Bulletin No.: TS-01
Release Date: Nov 1, 2005
Effective Date: Immediately
Supercedes: None
Completion Date: Dec 2005
Page: 1 of 1

SERVICE BULLETIN

Ride Manufacturer: Sellner Manufacturing Company
Ride Name: Jalopy Junction, Rocktown
Model Number: 560XXX-XX

Abstract Of Issue: Vehicle Wheel Wear Limits

VIEW OF DRIVE VEHICLE SHOWING LOCATIONS OF WHEELS

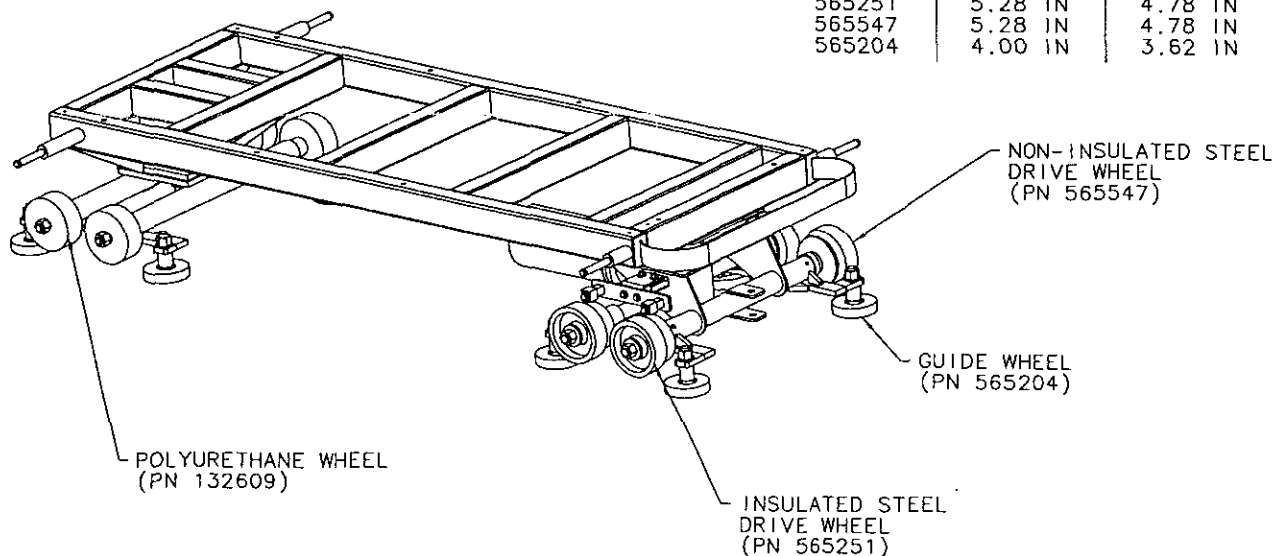
Sellner Manufacturing Company did not put a provision of wheel wear limits in its Service Manual. This Service Bulletin will provide that provision. If the wheel dimension is less than the minimum value, the guide wheel pin may potentially come into contact with the track ties. Sellner Manufacturing will have the wheel wear limit provision in the next revision of the Service Manual.

All vehicle wheels should be checked for tolerance annually. Three measurements should be taken for each wheel: both ends and the center. The smallest value shall be used for the wheel diameter. If the measured value of the wheel is less than the dimension listed below, the wheel should be replaced. The owner/operator should inform, and make readily accessible to, all employees who set-up, operate, teardown, or maintain this ride of this bulletin.

The minimum diameter for the polyurethane wheels (part number 132609) is 4.50 inches. (24 per ride)
The minimum diameter for the steel drive insulated wheels (part number 565251) is 4.78 inches (4 per ride)
The minimum diameter for the steel drive non-insulated wheels (part number 565547) is 4.78 inches. (4 per ride)
The minimum diameter for the guide wheels (part number 565204) is 3.62 inches. (32 per ride)
